SUNDRY NOTICES AND REPORTS ON WELLS
Do not use this form for proposals to drill or to re-enter an abandoned well. Use Form 3160-3 (APD) for such proposals.

8. Well Name and No. **Hinkle F 4**

9. API Well No. **30-015-10593**

RE: Plugging and Abandonment Requirements, Conditions of Approval

Hinkle F #4

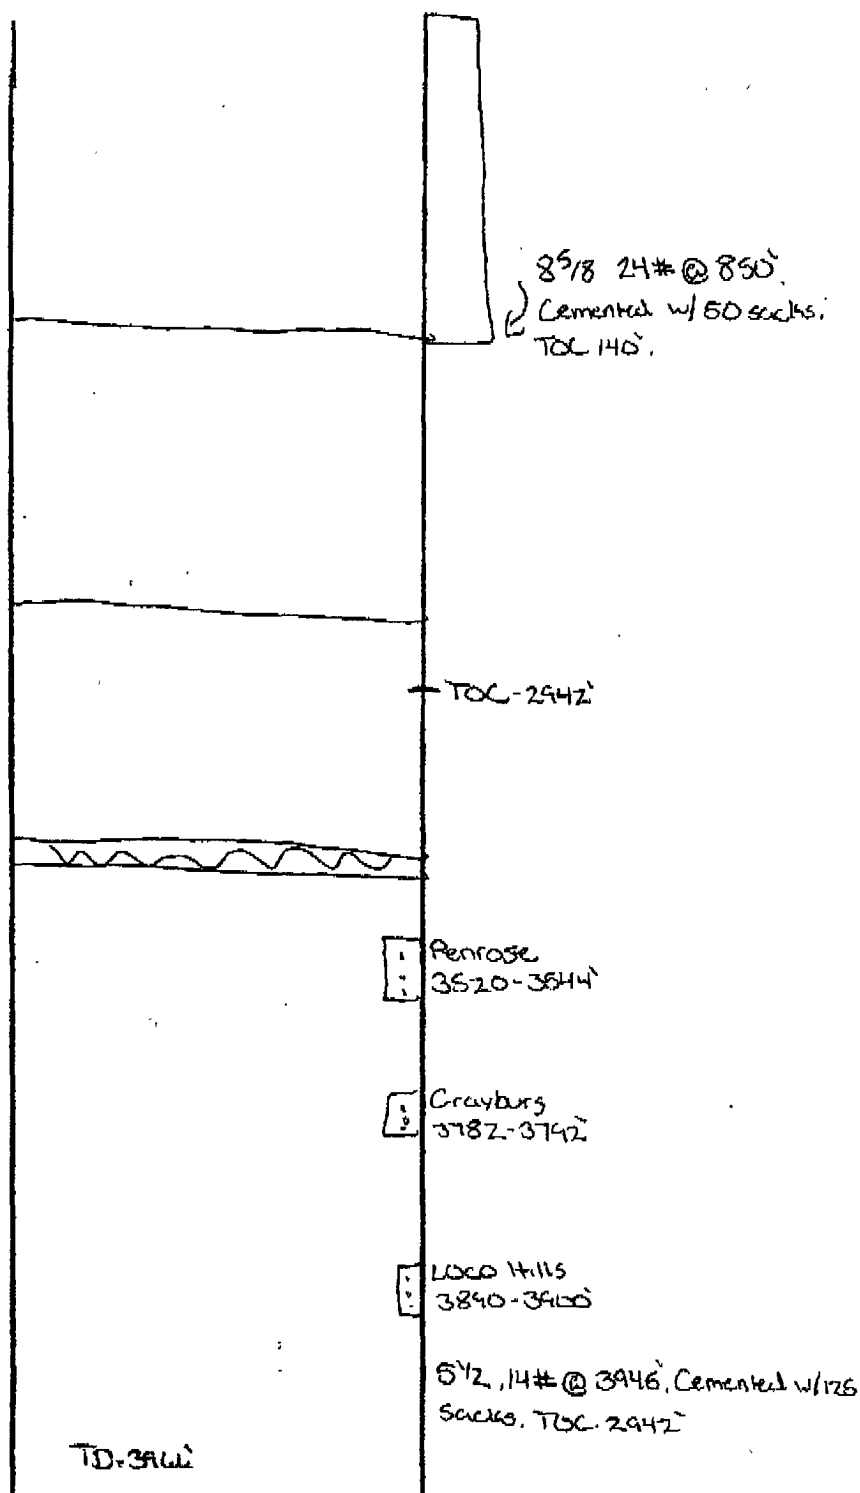
1. Move CIBP to 3470' – Otherwise OK (Perfs)
2. If injection rate cannot be established, spot plug 50' below perfs. Tag at 1875' or shallower – Otherwise OK (BOS)
3. Perf and squeeze plug from 900'-840'. If injection rate cannot be established, spot plug 50' below perfs. WOC and tag at 840' or shallower. (TOS – Casing shoe)
- 3a. Perf and squeeze a plug from 60' to surface. Make sure to fill all annuluses. (Surface)
4. OK
5. Submit a subsequent report to the BLM.
